F3
29.6.26

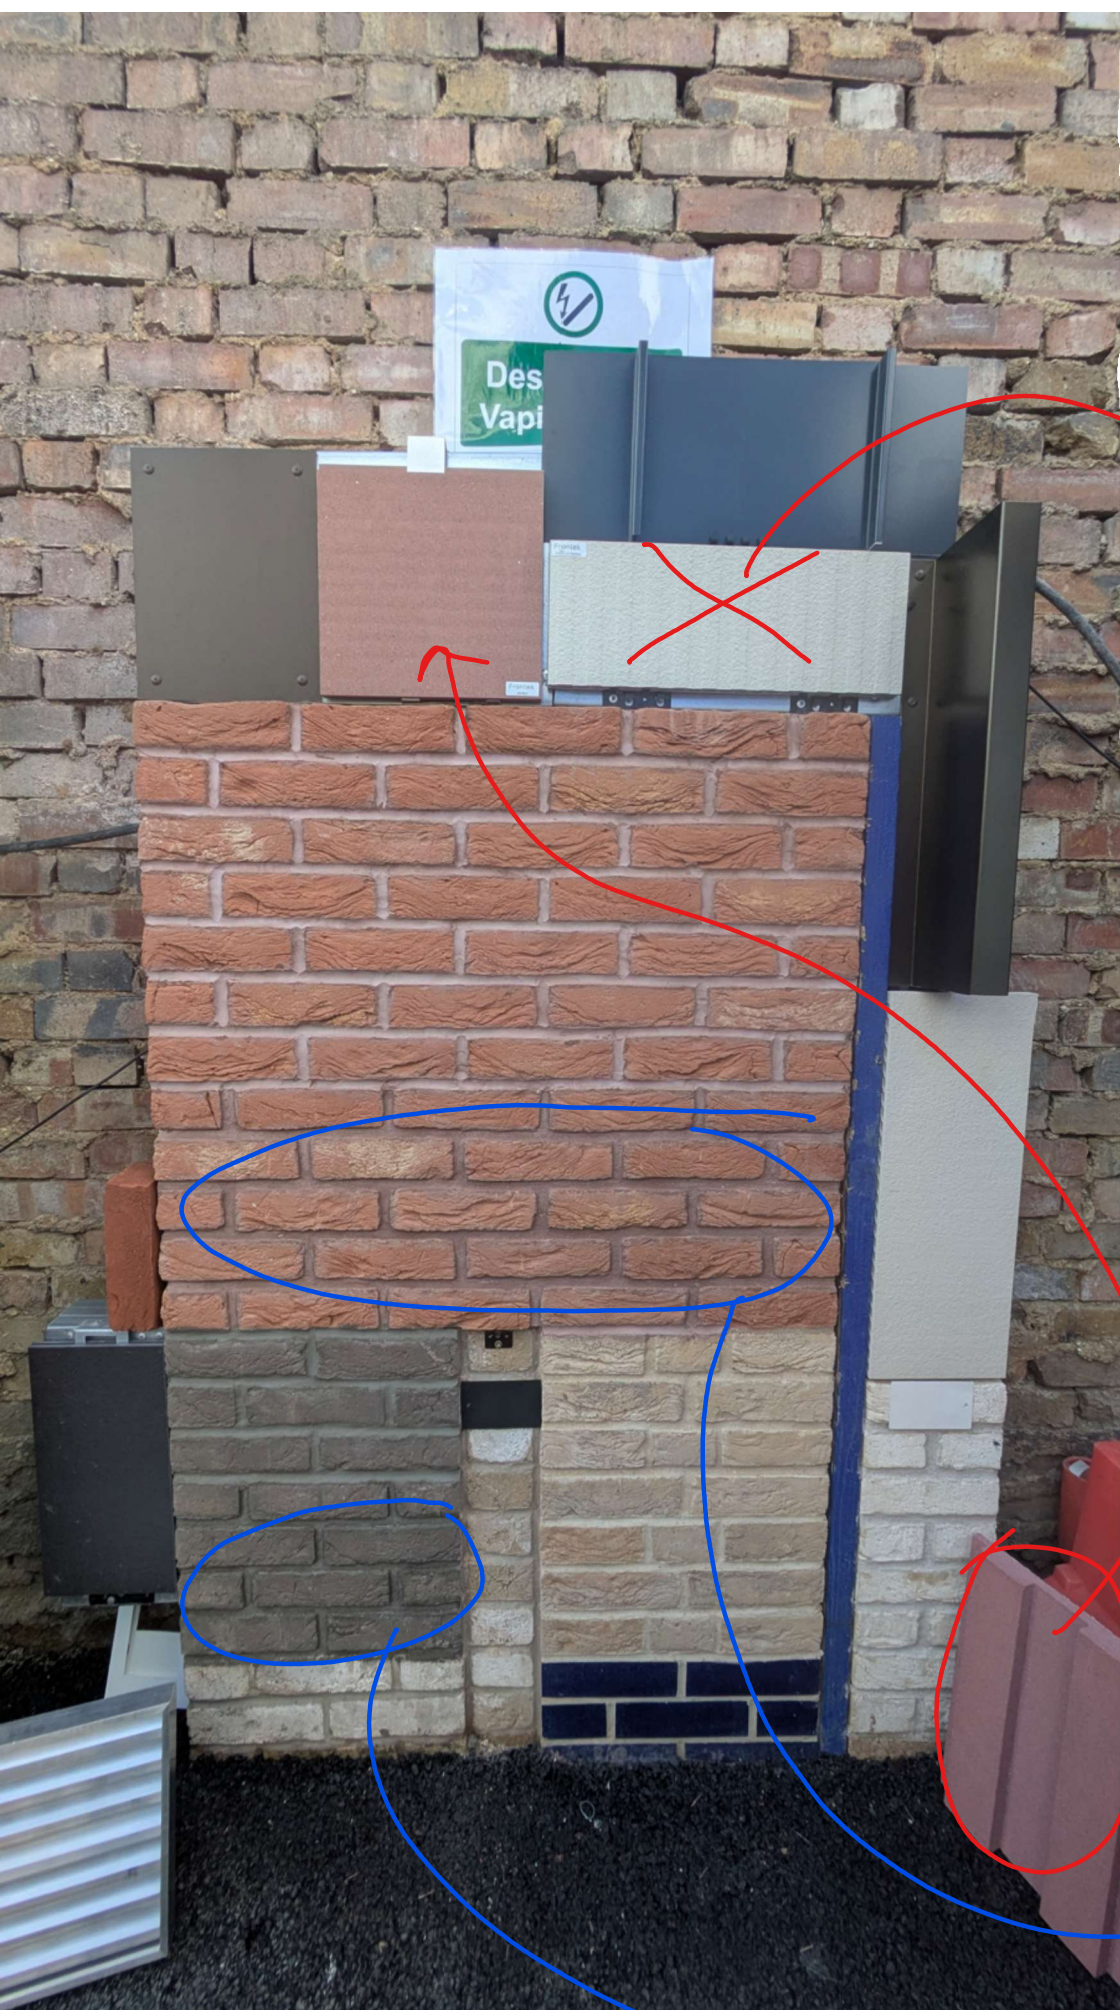
RIB PROFILE TOO SHALLOW.
NOT ACCEPTED

SELECTED MORTAR COLOURS
CONSISTENT FINISH IS
ACHIEVED WHEN MIXED IN
THE SILO

DEEP RIB PROFILE SELECTED.
FINISH TO MATCH RED FRONTEK
SAMPLE VISIBLE AT THE TOP OF THE
PANEL
